Bullawah Wind Farm Project

Telecommunications Impact Assessment

Client: Umwelt (Australia) Pty Ltd

Doc no: 23048-E-RPT-0001

Figure 1. Turbine Impacts

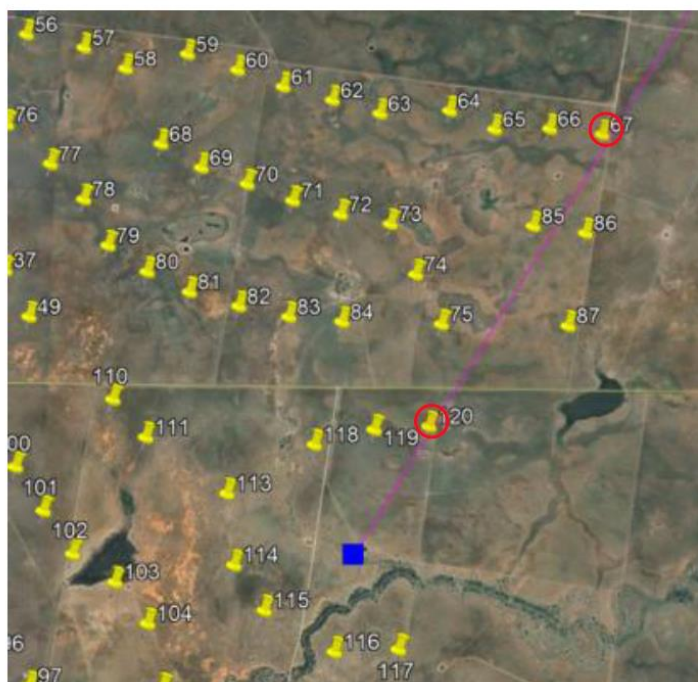
Turbines T67 and T120 encroach* on this radio path (please see Figure 1. below). It is requested that these turbines be relocated to at least 150 m from the turbine blade extent to the radio path.

Turbines T67 and T120 encroach* on this radio path (please see Figure 1. below). It is requested that these turbines be relocated to at least 150 m from the turbine blade extent to the radio path.

*The criteria used for encroachment (and therefore clearance): The 1st and 2nd Fresnel zones of the radio path must be free from obstructions.

Could you please confirm that following cancellation of the service by the landowner, at that time Telstra would have no objection to the proposed positioning of the turbines and would no longer request they are relocated as per Item 2 of the response (attached and below).

- WTG67: The Telstra CAN link passes within the vicinity of WTG 67 in the horizontal plane. However, the analysis above (cross-section figures) show that the link is below the WTG rotors vertically. The furthest extent of the rotor and the edge of the 2nd Max Fresnel zone is shown as 50 m in the cross-sectional view above. There is no indication that this link will be affected by WTG 67.
- WTG 120: The link will not be affected by WTG 120's rotors (similar reason as above). The furthest extent of the rotor and the edge of the 2nd Max Fresnel zone is shown as 40 m in the cross-sectional view above. There is a possibility that the tower itself may interfere with this signal.
